RECALL BULLETIN

DATE: OCTOBER 2, 1995
MODEL YEAR: 1995
MODELS AFFECTED: UD1800/UD2300/UD2600/UD3000
BULLETIN #: SC-176
FILE AT END OF ELECTRICAL SECTION IN TECHNICAL BULLETIN BINDER

VOLUNTARY SAFETY RECALL CAMPAIGN #95V-176
(FORMERLY INTRODUCED AS PI-026 DATED APRIL 19, 1995)

WIRING HARNESS PROTECTOR

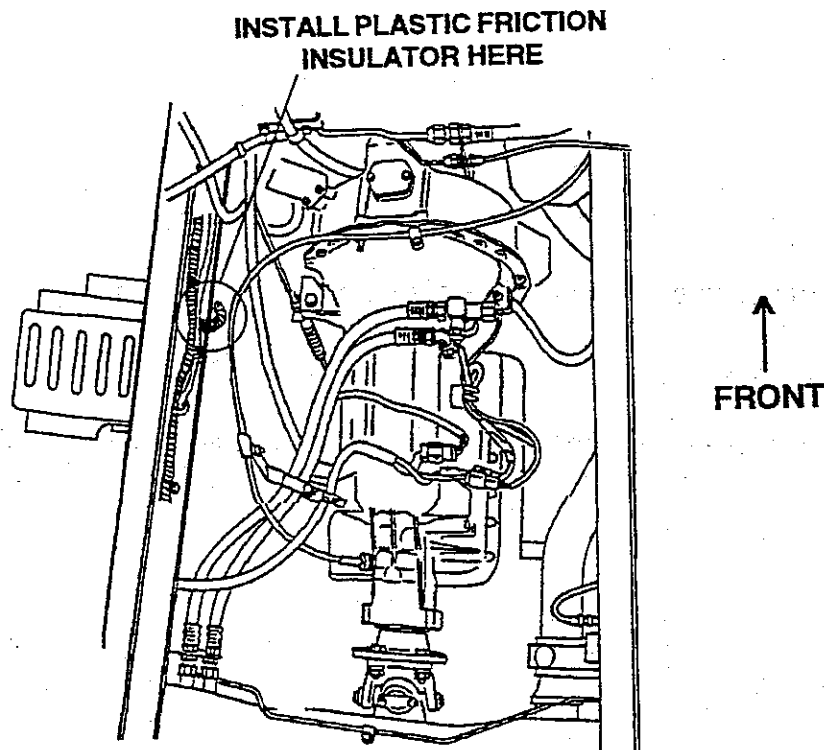
The possibility exists that the vehicles may experience wiring harness protector chafing or rubbing on the driver's side lower frame rail flange, causing possible breakage of the wiring harness protector and exposure or breakage of the wiring. Breakage of the wiring could cause loss of electrical power to various components or systems, including the headlights and windshield wipers.

The repairs to correct this condition consist of the installation of a plastic friction insulator on the lower frame rail flange between the flange and the wiring harness protector. If the protector or any of the wiring has been broken, it should also be repaired.

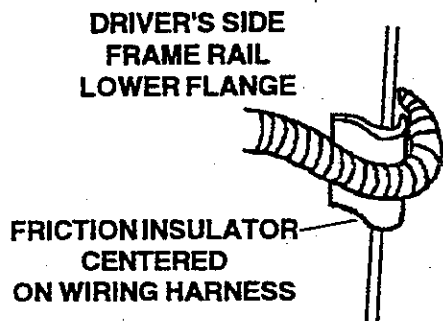
If the wiring harness protector is torn or separated, apply electrical tape to the affected area to seal the harness protector, then install the friction insulator. If any of the wires are exposed or broken, repair the affected wires, apply electrical tape to the affected area of the harness protector, then install the friction insulator.

Install the plastic friction insulator on the frame rail lower flange with a permanent adhesive such as Super Glue, 3-Bond, Quicktite, or a suitable equivalent. The insulator should be centered on the wiring harness as shown in the figure below.
